BUNKER LAKE INDUSTRIAL PARK
BUILDING #5
Ramsey, Minnesota

BLIP V DEVELOPMENT PLANS

CITY OF RAMSEY, MINNESOTA

BUILDING ELEVATIONS

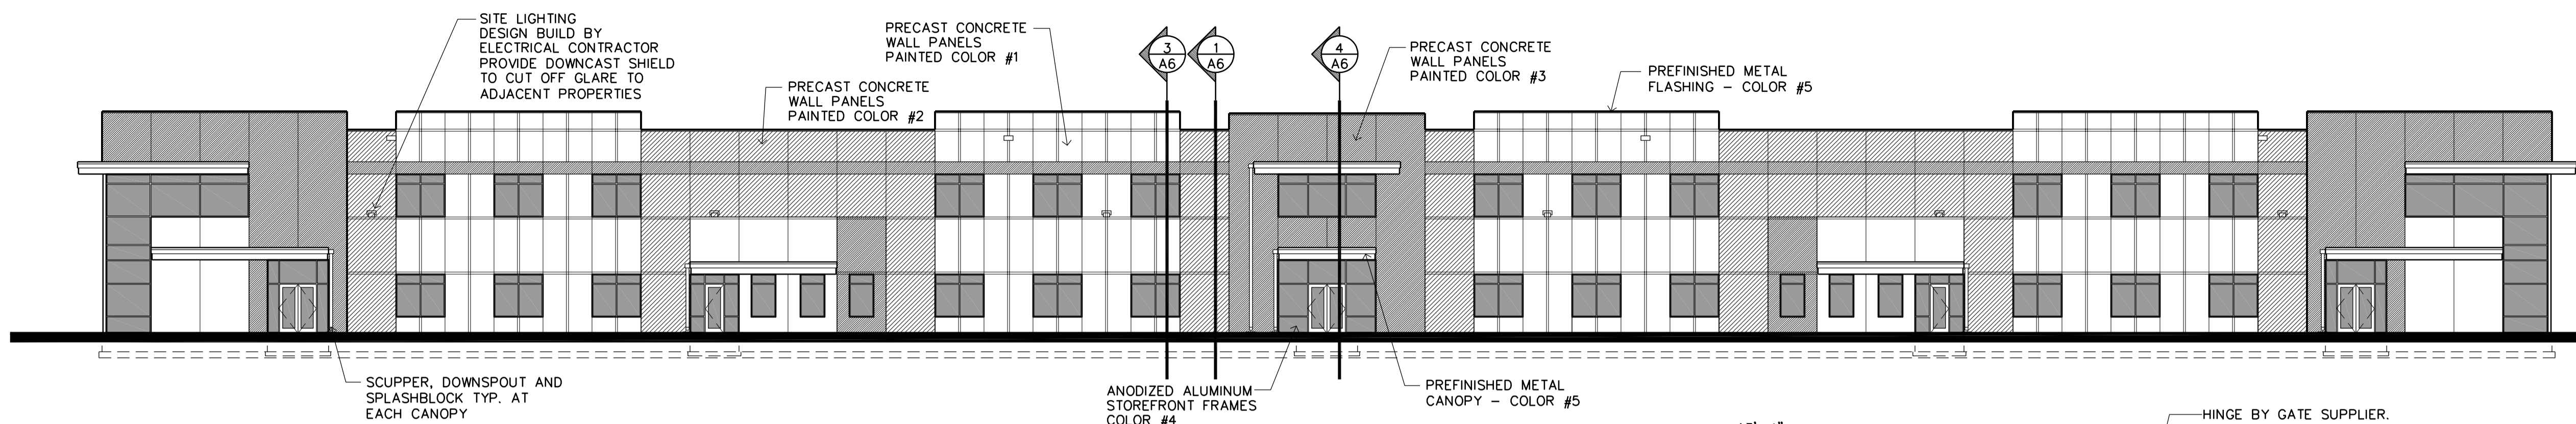
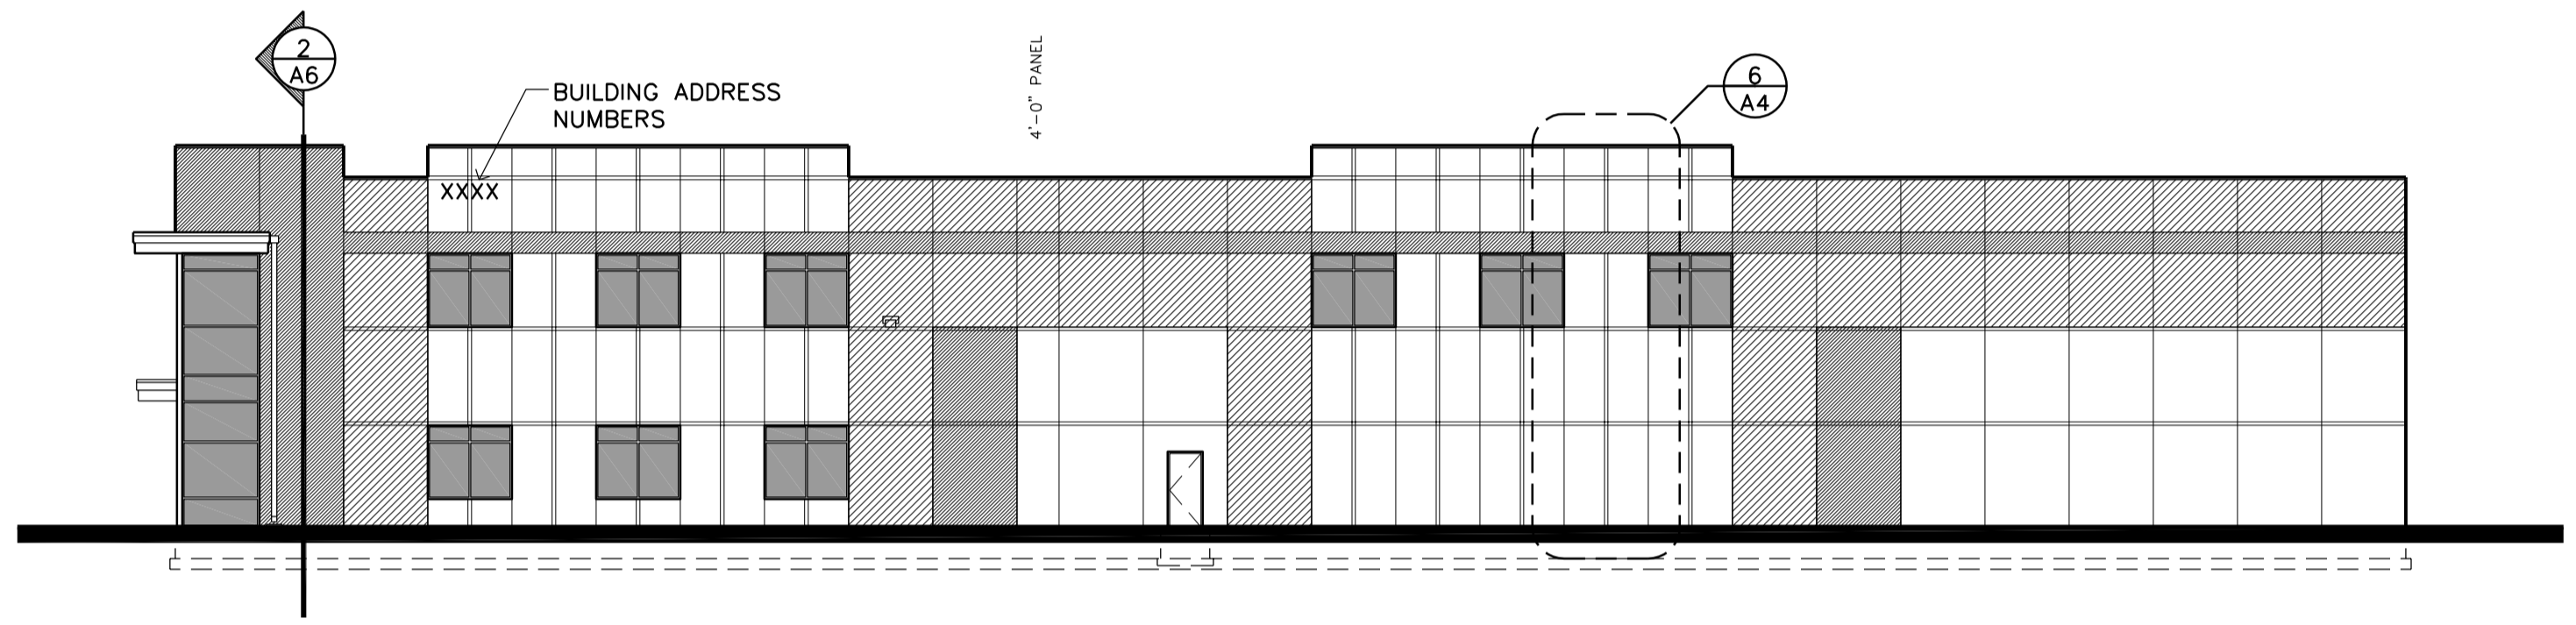
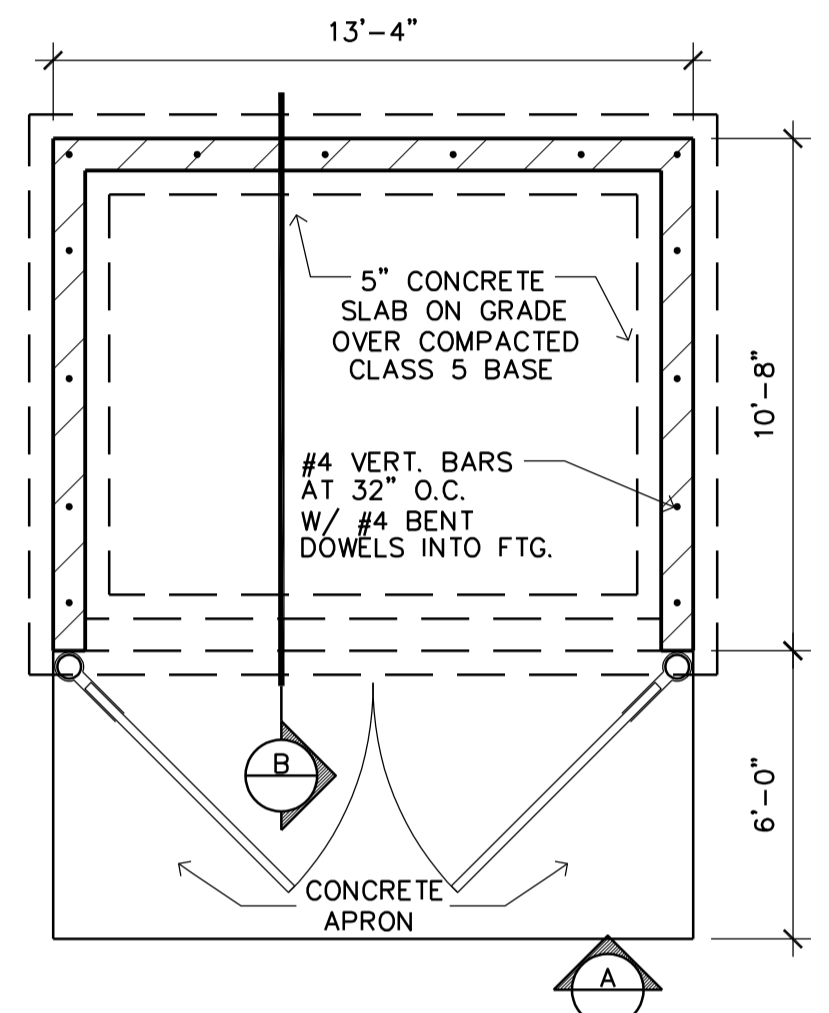
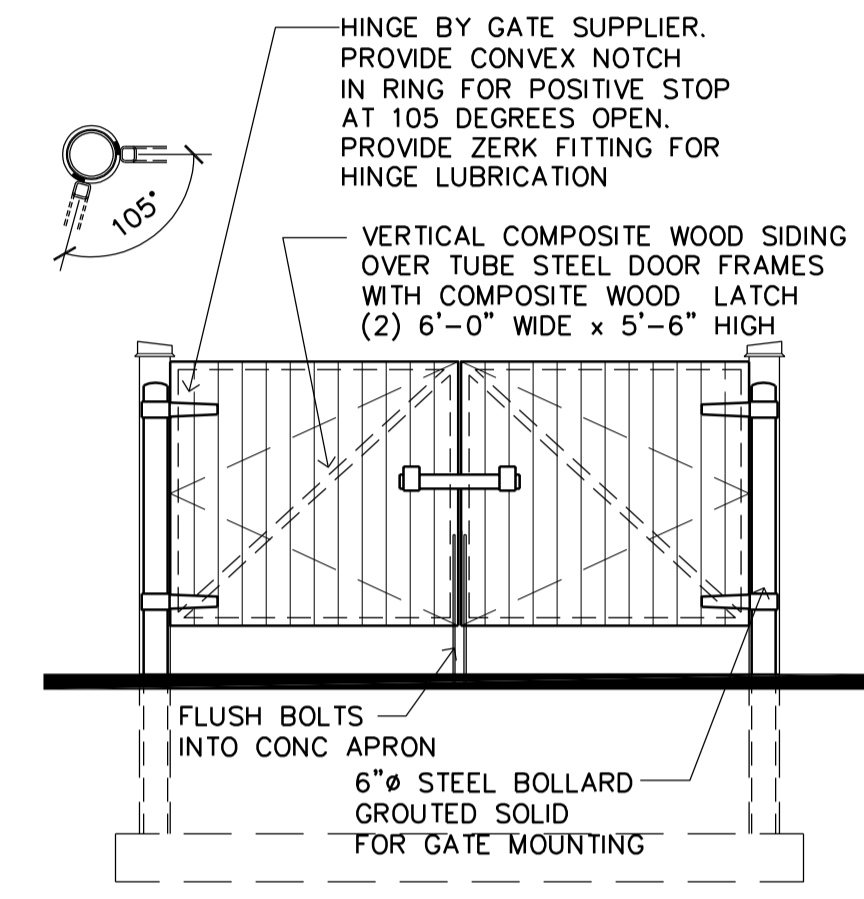
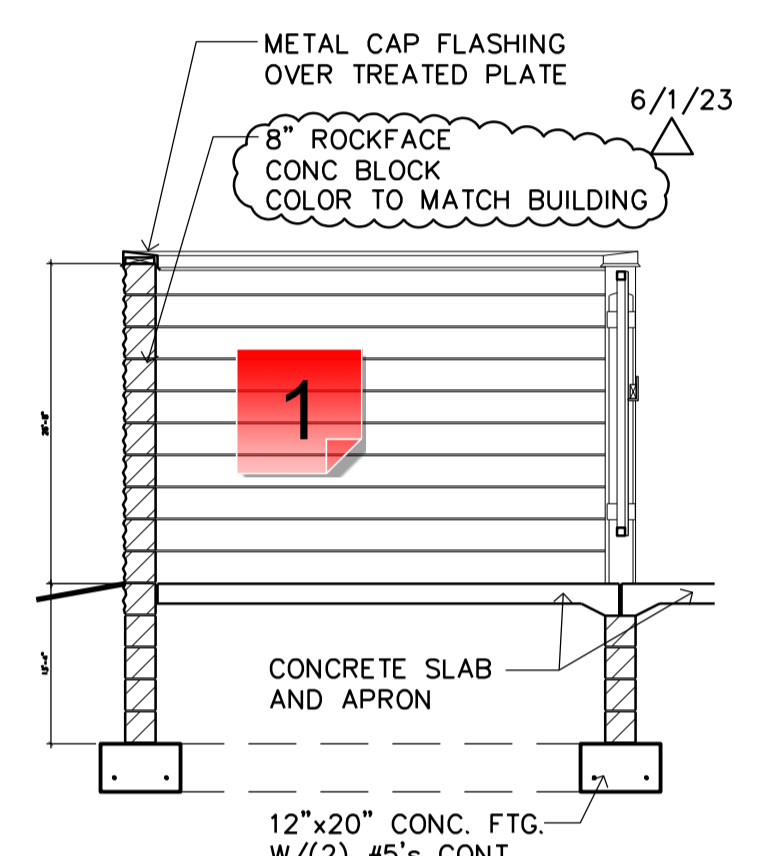
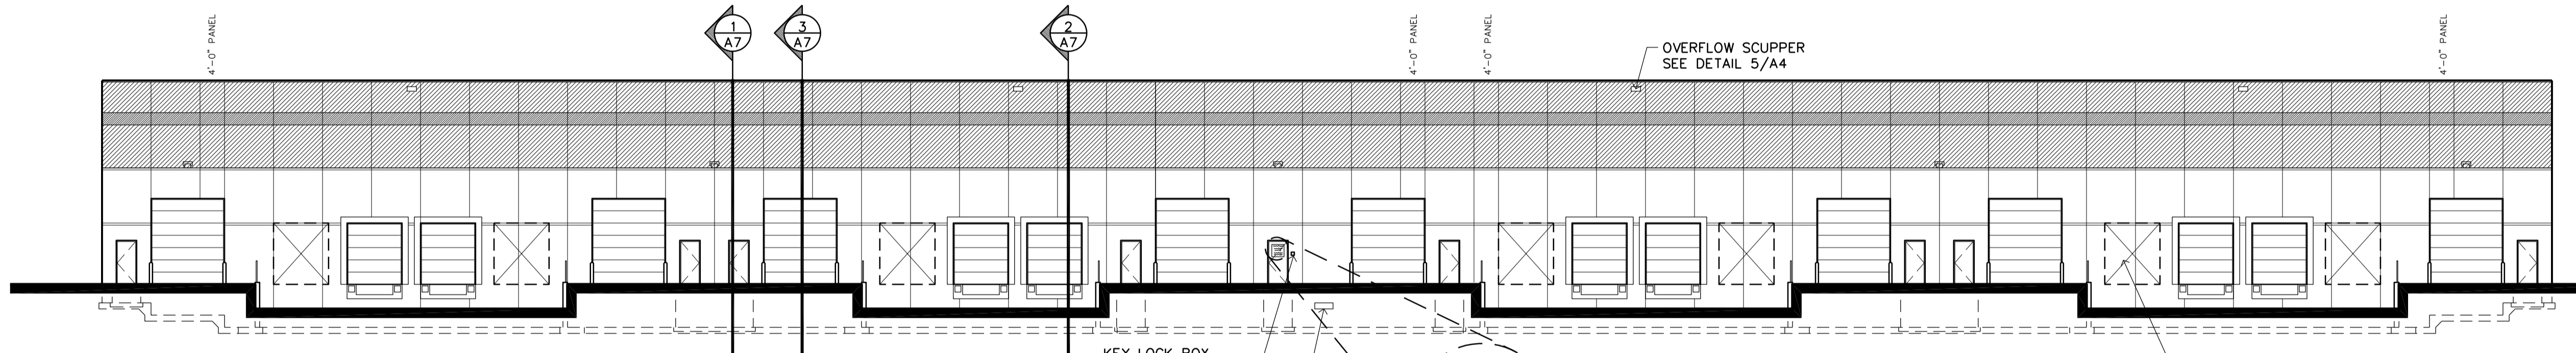
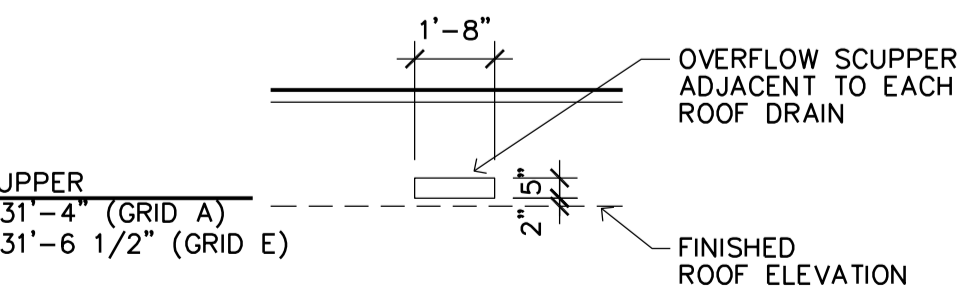
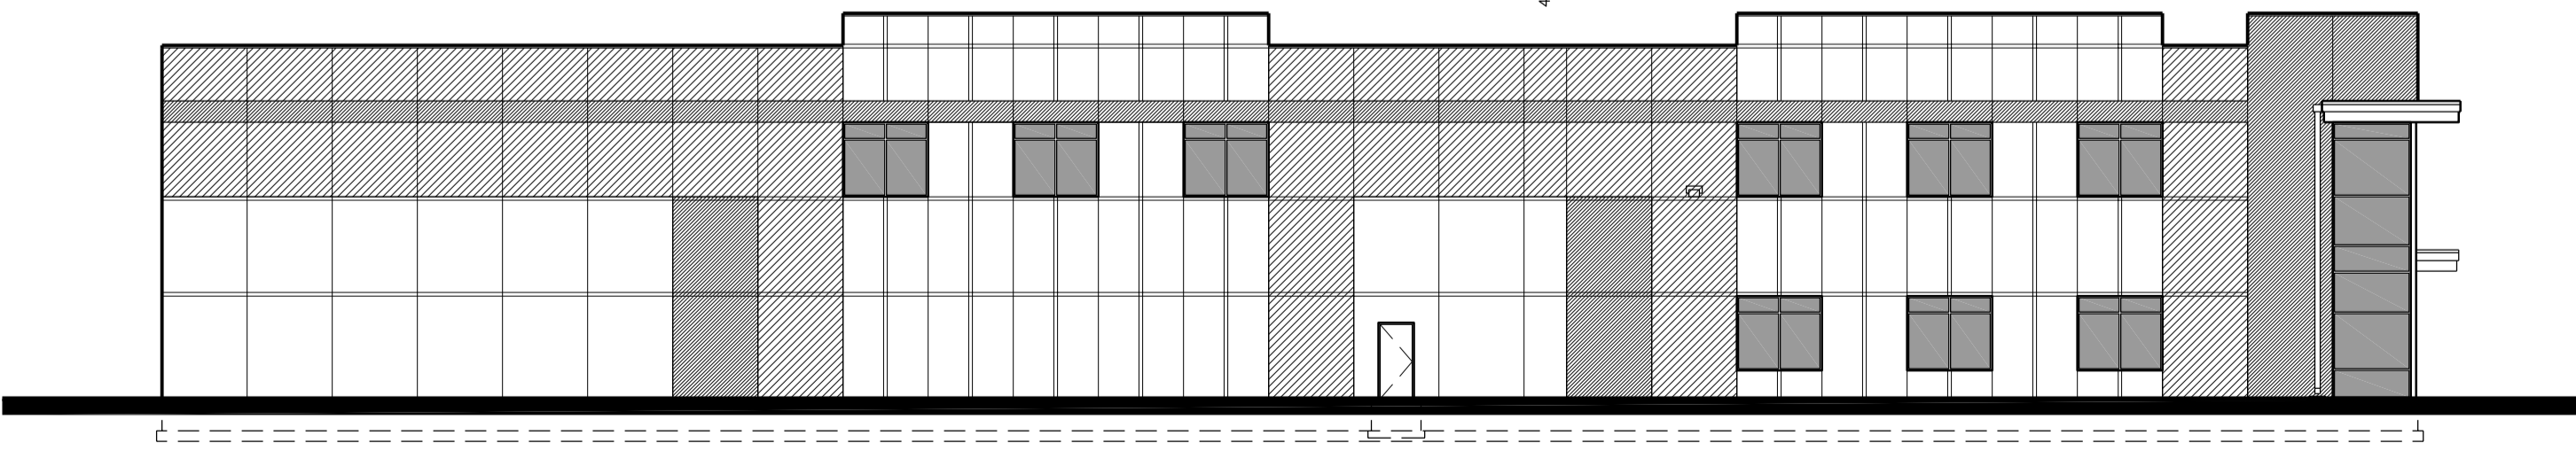
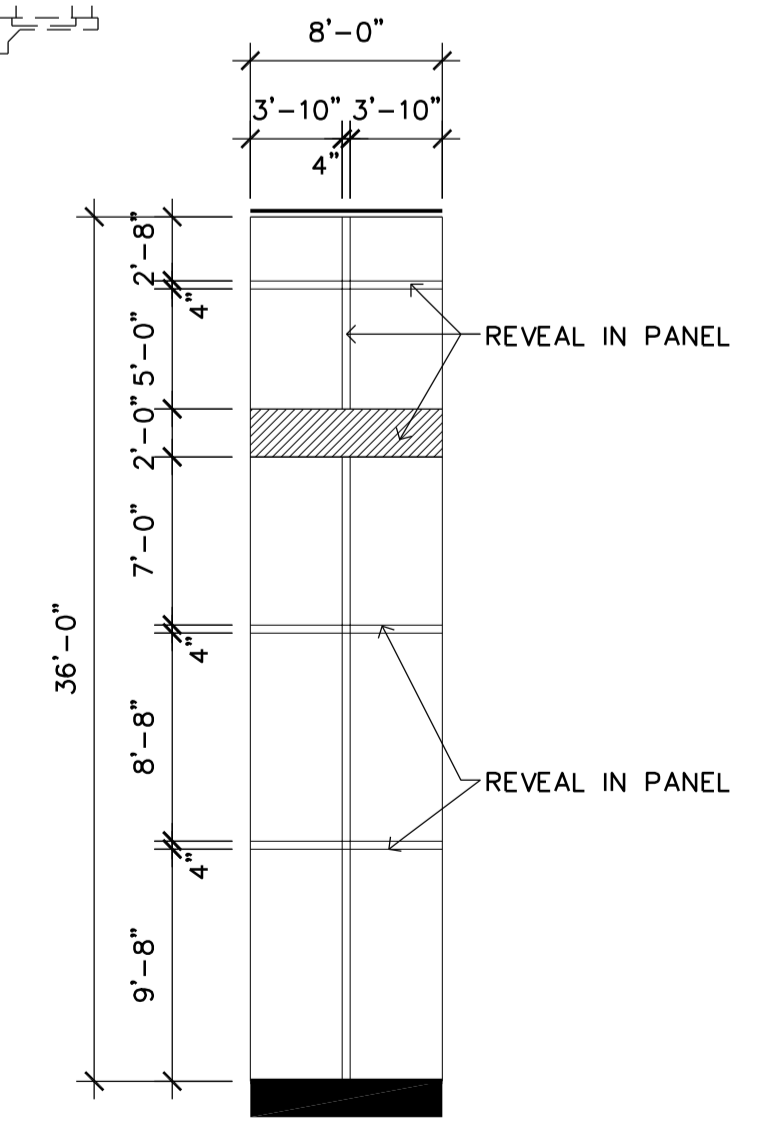
1 - Material?

What is the horizontal lap material? There is a notation (6/1/23) indicating that this was updated from the initial submittal but no corresponding note on this sheet.
